Access Compliance Report

Public Rights-of-Way

(Curb Ramps)

Intersection ID: 23917	Main Street: BOSHAM_LN	Cross Street: WHITWORTH_WY	Location: NE
ADA ID: E3BE3E16111C	Ramp Type: Perp	Initial Pass/Fail: Fail	Overall Compliance: No
Severity Score: 10			
Codes/Mitigation Info/Possible Solution		Field Measurements/Component Compliance

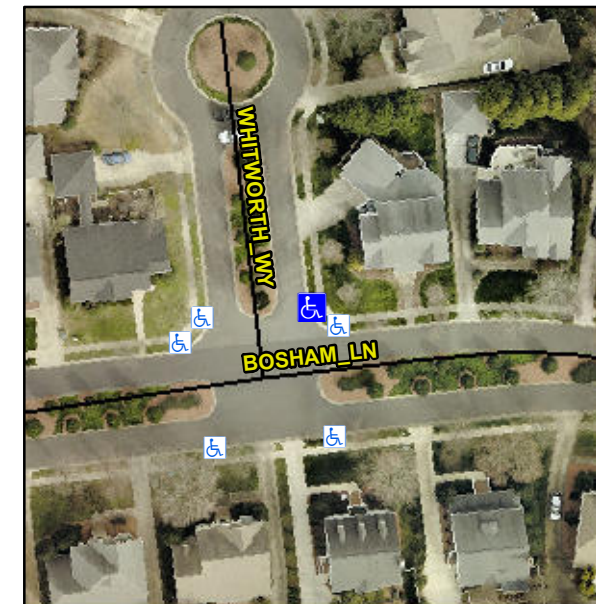
Not Found, R304.5.1, R304.5.3

Compliance	Description	Data	Compliance	Description	Data
N/A	Ramp Length (in)	47.0	Yes	Ramp Slope (%)	8.2
No	Ramp Width (in)	46.5	No	Ramp XSlope (%)	2.9
N/A	Flare Type LT	N/A	N/A	Flare Type RT	N/A
N/A	Flare Slope LT (%)	N/A	N/A	Flare Slope RT (%)	N/A
N/A	Flare Traversable LT?	N/A	N/A	Flare Traversable RT?	N/A
N/A	Landing Length (in)	N/A	N/A	DWS Provided?	N/A
N/A	Landing Width (in)	N/A	N/A	DWS Contrast?	N/A
N/A	Landing Slope (%)	N/A	N/A	DWS Length (in)	N/A
N/A	Landing X Slope (%)	N/A	N/A	DWS Full Width?	N/A
N/A	Landing Curb? (Y/N)	N/A	N/A	DWS Offset (in)	N/A
N/A	Shared Landing?	N/A			
N/A	Gutter Ponding?	N/A	N/A	Gutter Slope (%)	N/A
N/A	Gutter Lip Ht (in)	N/A	N/A	Gutter X Slope (%)	N/A
N/A	Painted X Walk1?	No	N/A	Painted X Walk2?	N/A
	X Walk 1 Direction	To W		X Walk 2 Direction	N/A
N/A	X Walk 1 Width (in)	N/A	N/A	X Walk 2 Width (in)	N/A
	X Walk 1 Slope (%)	2.9		X Walk 2 Slope (%)	N/A
	X Walk 1 X Slope (%)	1.4		X Walk 2 X Slope (%)	N/A

Remove & Replace Entire Ramp.
